RECORD DRAWING

Co. Rd. 575 S / ROWENA CT. LINE "RS"	
FALL CREEK R.W.D. PLAN & PROFILE SHEET	
HORIZ. 1"=50'	BEAM, LONGEST & NEFF, INC. CONSULTING ENGINEERS INDIANAPOLIS, INDIANA
VERT. 1"=10'	48

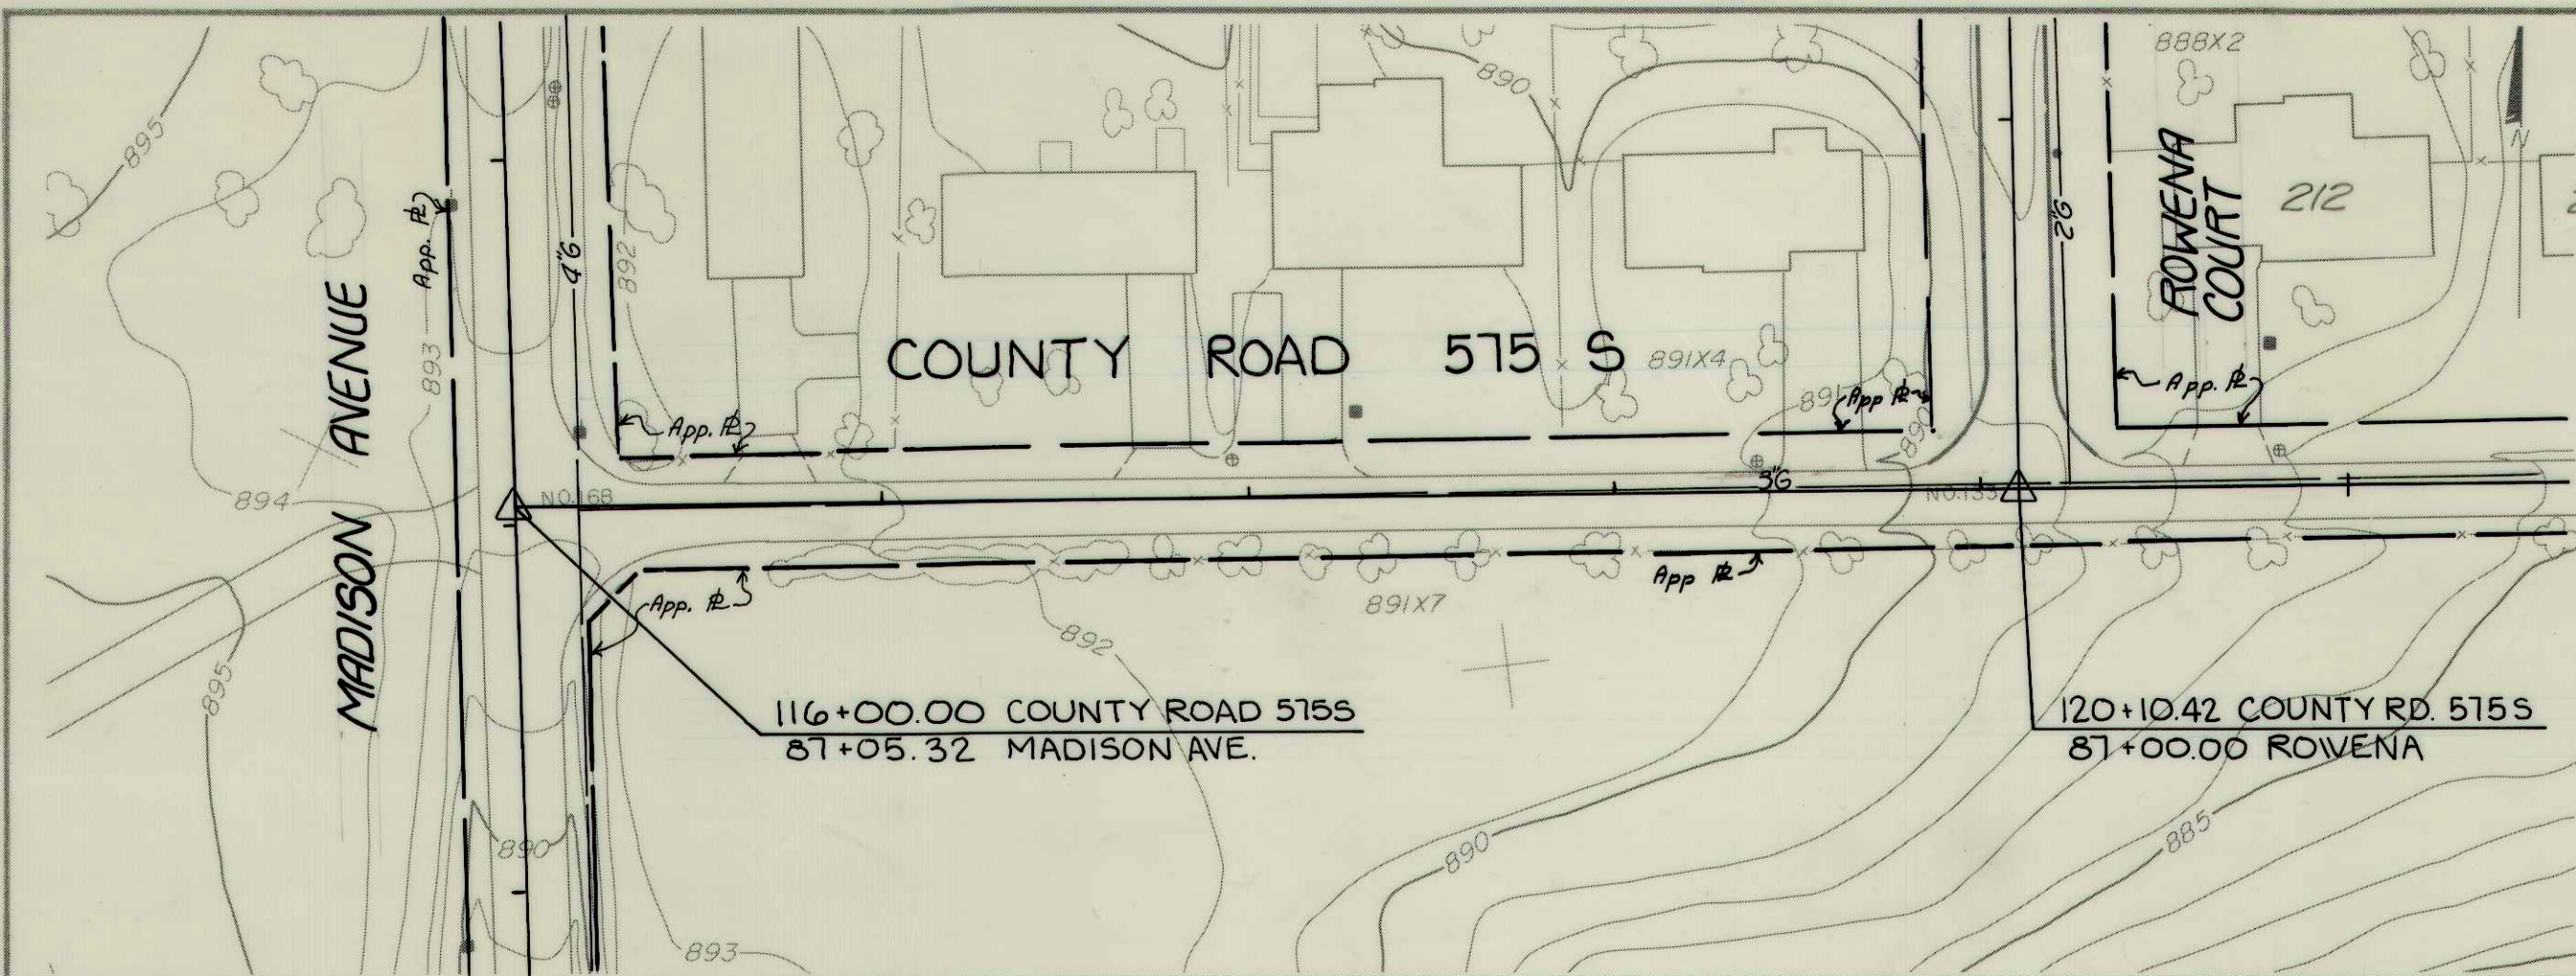
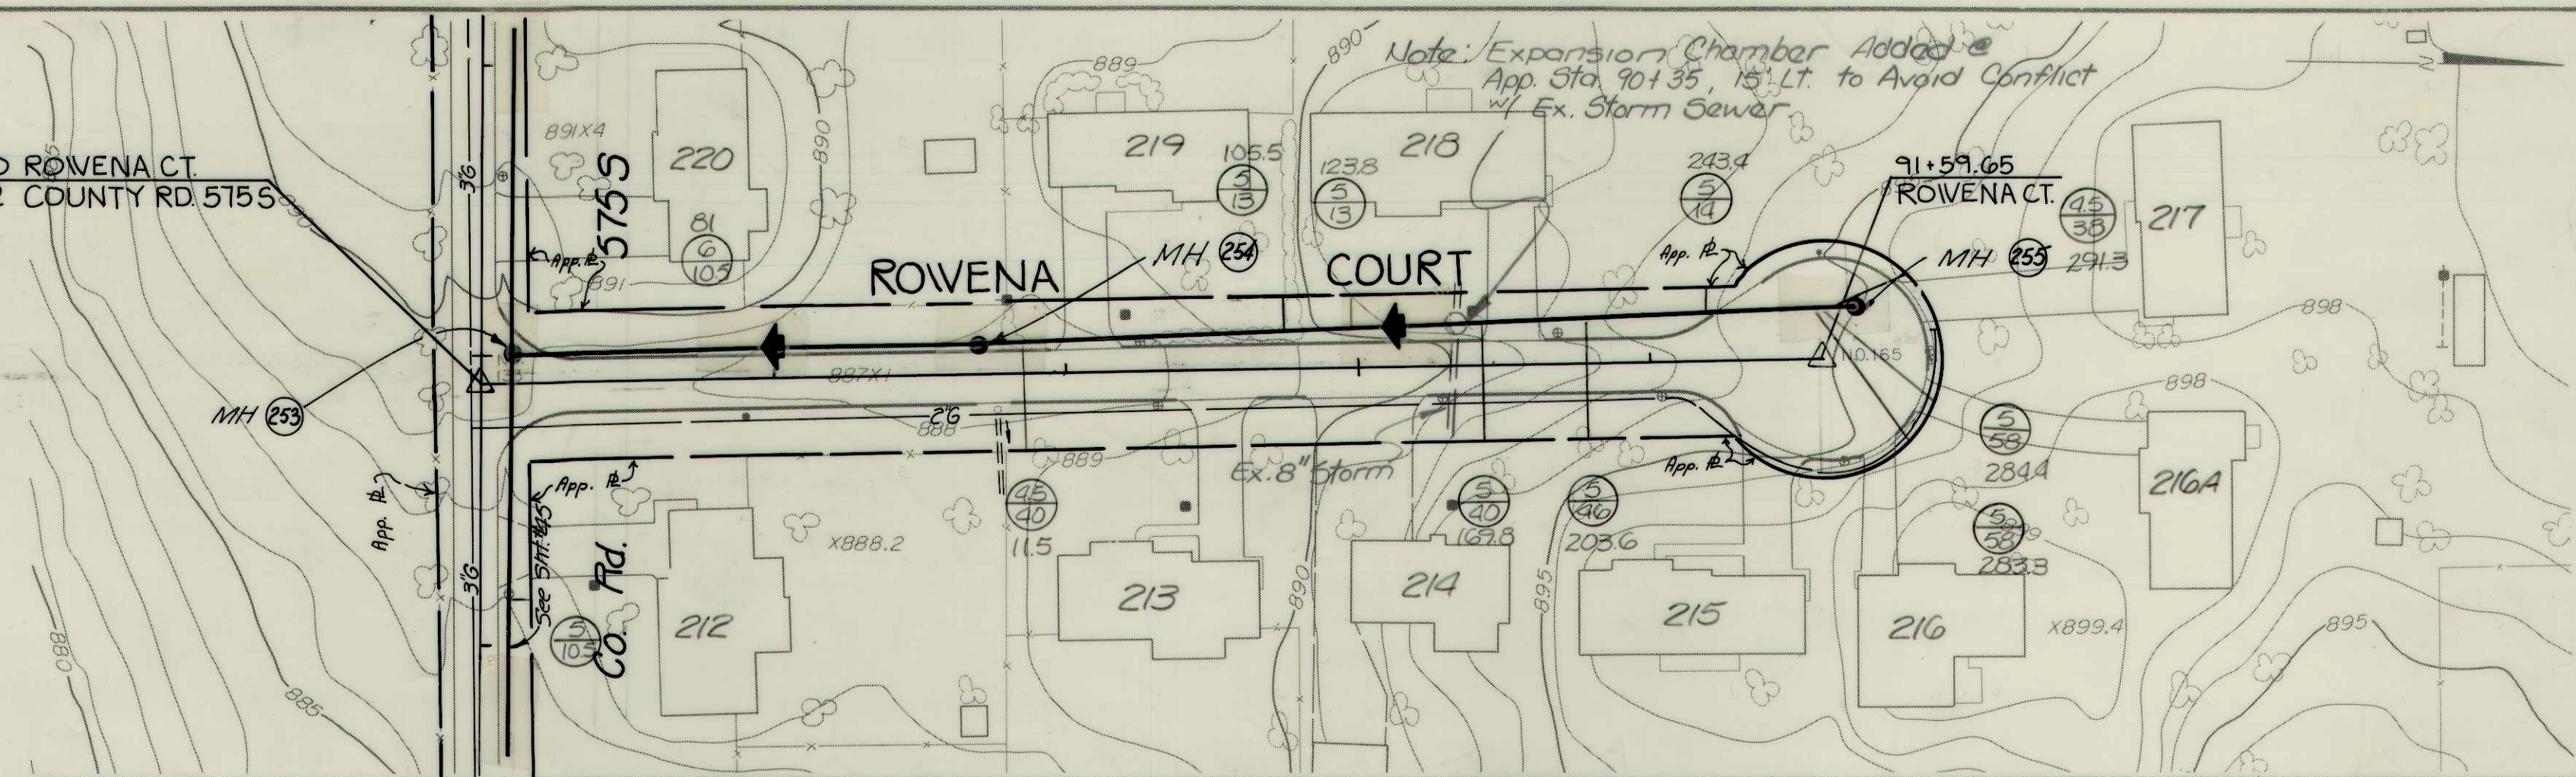
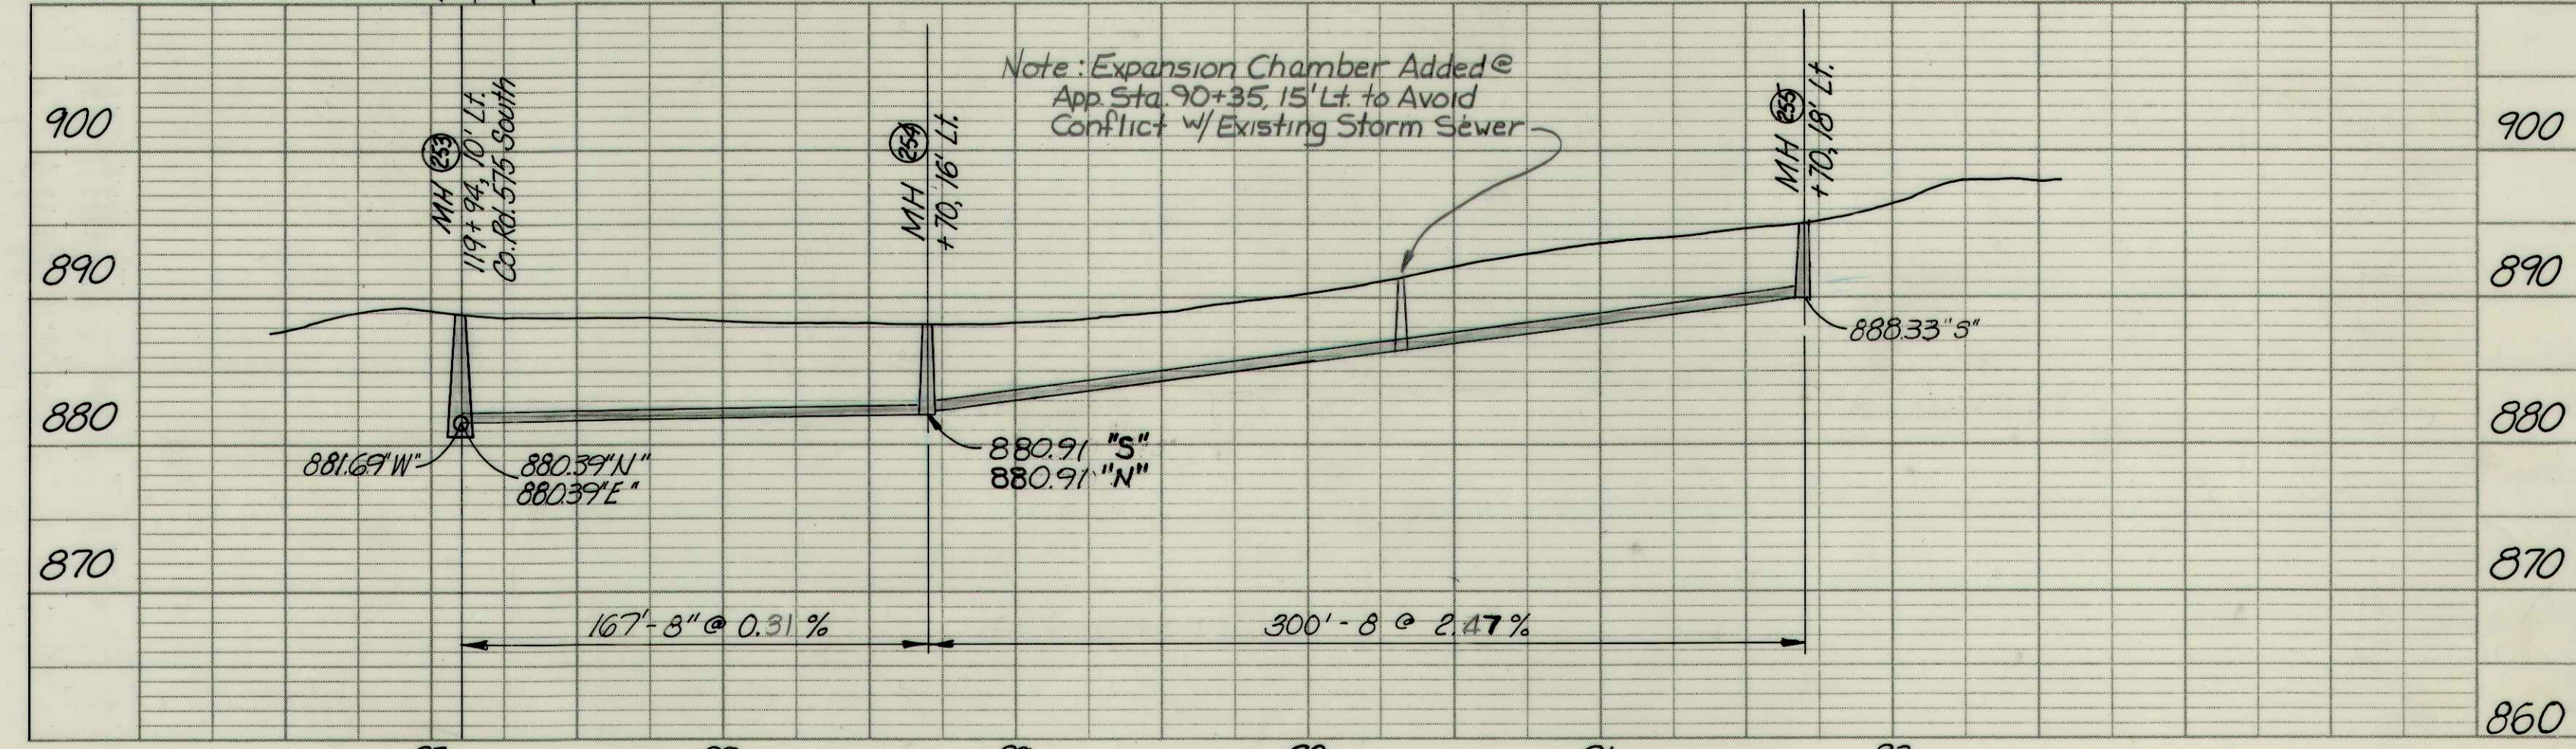
Note: Expansion Chamber Added @
App Sta. 90+35, 15' Lt. to Avoid Conflict
w/ Ex. Storm Sewer

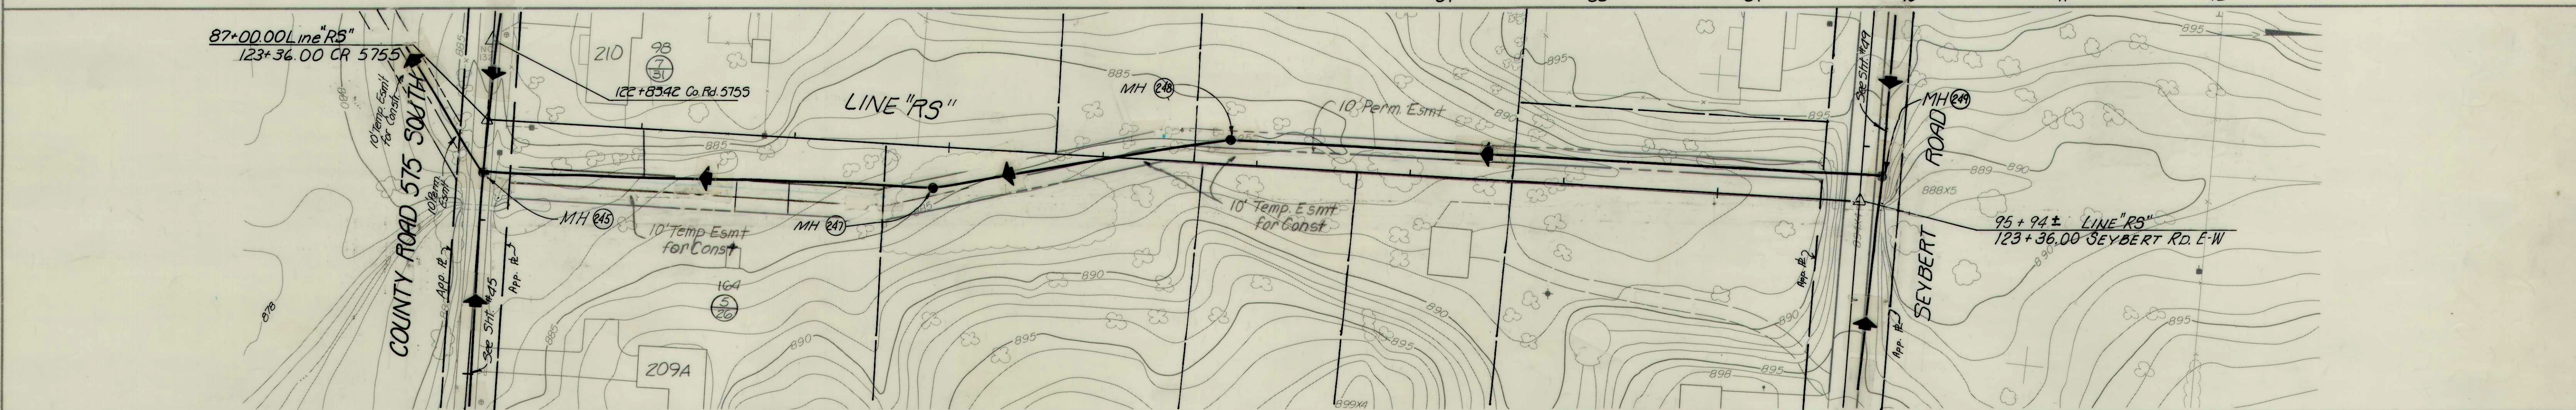
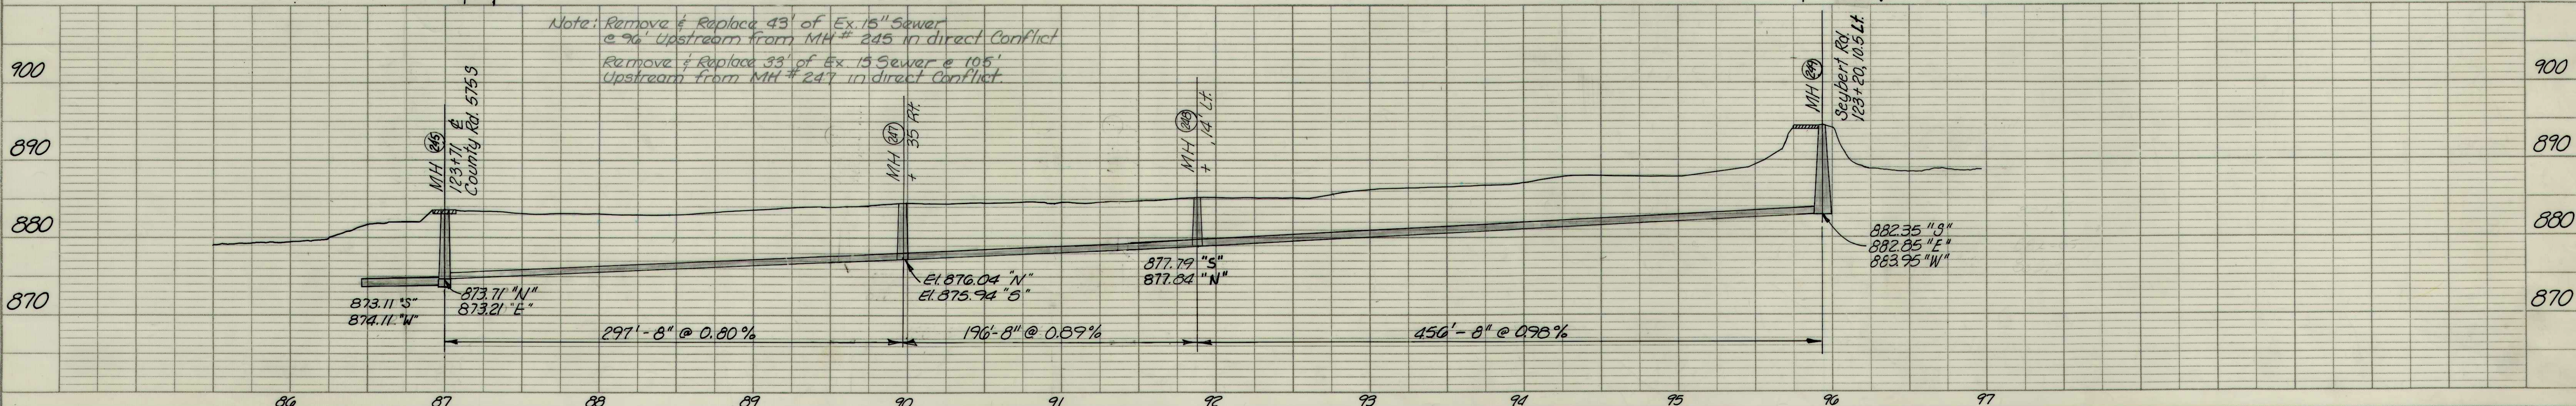
Note: Remove & Replace 43' of Ex. 15" Sewer
e 96' Upstream from MH # 245 in direct Conflict
Remove & Replace 33' of Ex. 15" Sewer e 105'
Upstream from MH # 247 in direct Conflict.
